PPPL ENGINEERING CHANGE NOTICE (ECN) ECN # 5140R3

ECN TITLE: Changes to Modular Coil Lead Area Design

AREA OR PROJECT: NCSX

The purpose of these lead area design changes is to mitigate technical risks that have come to light in the course of testing the C1 Modular Coil. **Revision 2 changes highlighted in yellow and test removed has strikethroughs.** The following changes are proposed:

Figure 1

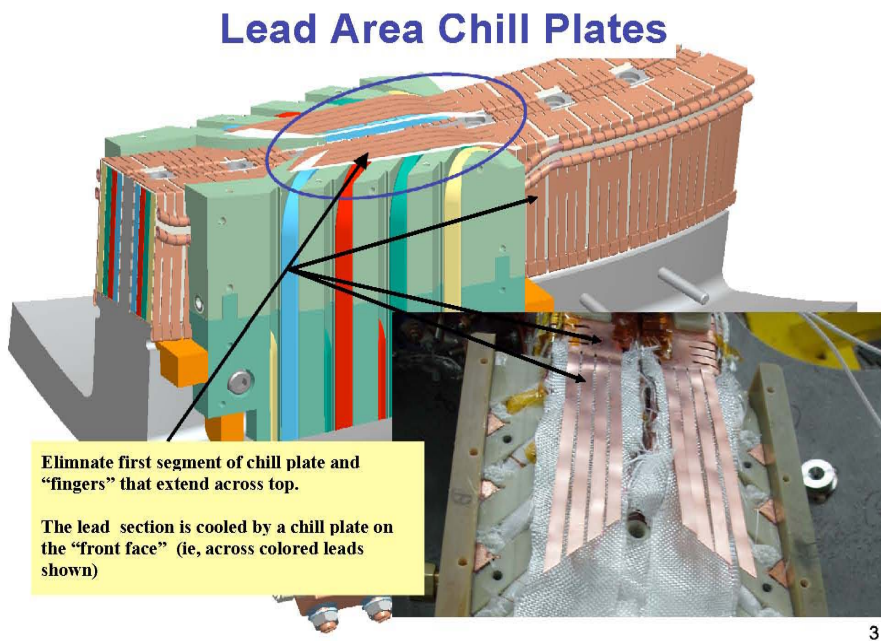
- On the top chill plate (the one with the long fingers that extend parallel to the coil) – cut off the fingers and eliminate the chill plate. **(See Figure 1)**. *This change will be implemented for the C3 and follow-on coils.*

Figure 2
Lead Area Cladding- Lower

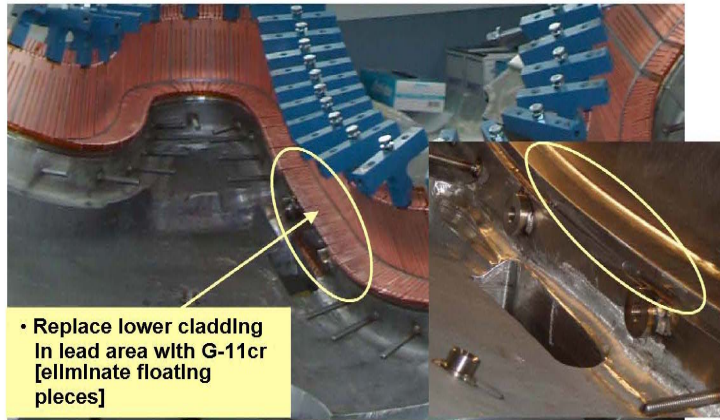
- Isolated copper cladding pieces (located on the base of the tee underneath the winding pack in the lead area, the vertical cladding pieces in the same area, and the cladding in the poloidal break area) – change the material to G-11cr. **(See Figure 2)**. *This change will be implemented starting with the C5 and follow-on coils. Note: The G-11 pieces should be made to look like the cladding (with slots) so that forming to the shape and wicking of epoxy will be that same as for other areas.*

Figure 3
Power Bus Tie-in Area

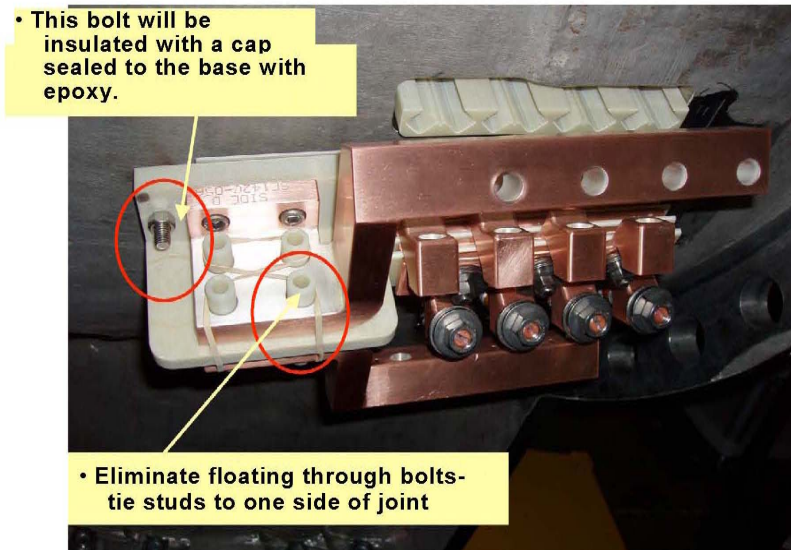
- For the power bus tie-in area, **install Kapton sheet over attachment bolt** ~~cap the attachment bolt with an epoxy seal~~ to mitigate a potentially short tracking path. **(See Figure 3L)**. *This will be implemented on all coils.*

- Presently the four bolts that connect the power bus are floating which is an undesirable condition **(See Figure 3R)** - connect them to one side by eliminating the insulating washers on the other side. *This will be implemented on all coils.*

Figure 5
Lead Area Floating Hardware

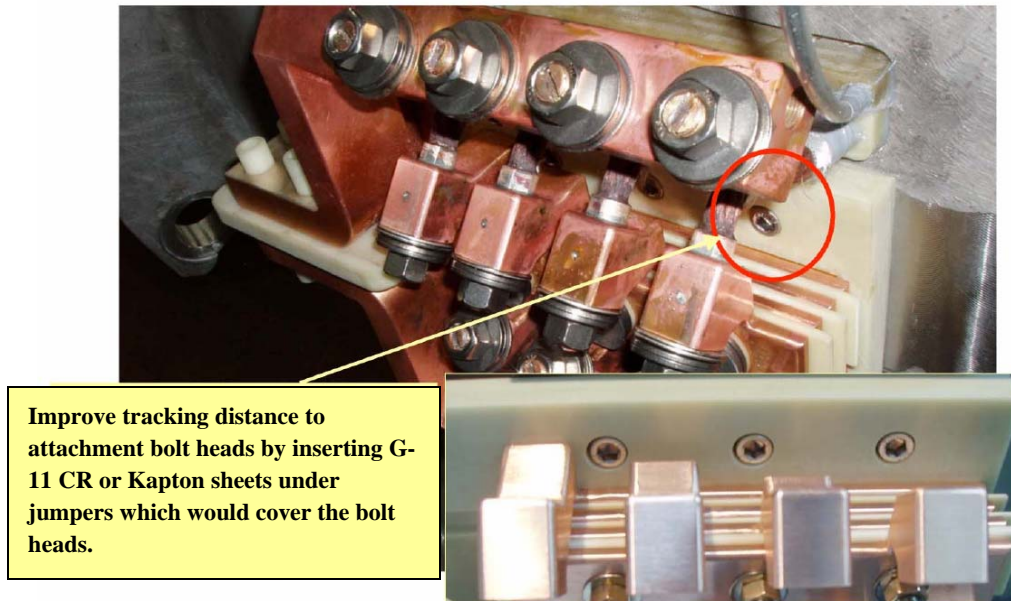
- For the three studs that bolt the stack of jumper plates together that are isolated – electrically tie them to one of the jumpers. **(See Figure 5)**. Also add an insulating “plug” at the base of the hole in the G-11 base plate to reduce the risk of the studs penetrating the G-11 backing sheet to the winding form. *This will be implemented on all coils.*
